JOB TITLE 3 The Grange, Worcester Park,
Surrey, KT4 7DJ

DWG TITLE Proposed First Floor Plan

DWG NO. 11617.17
© COPYRIGHT William Martin
Property Consultants
Limited - 7059387

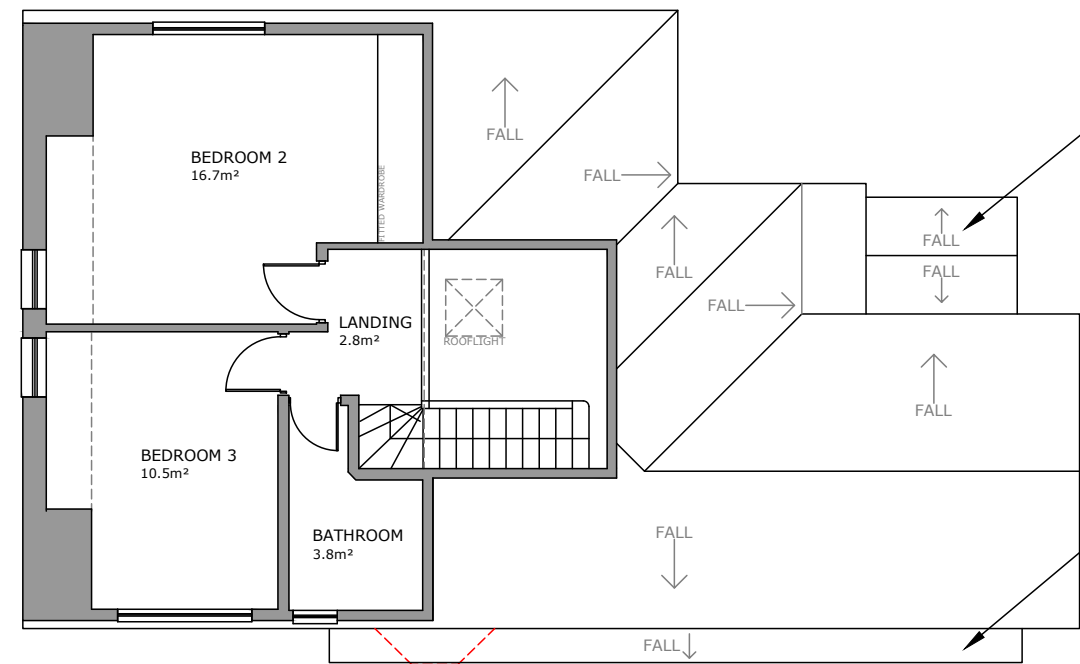
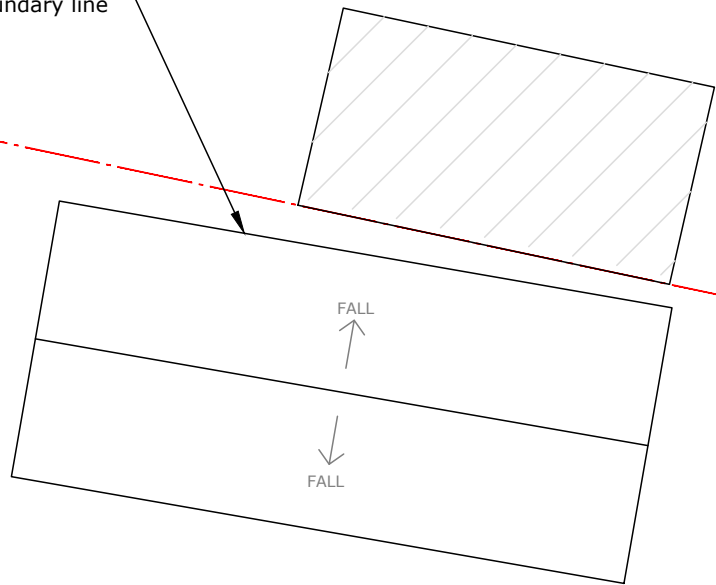
Rebuilt Therapy Room
outbuilding position revised to
be set away from boundary line
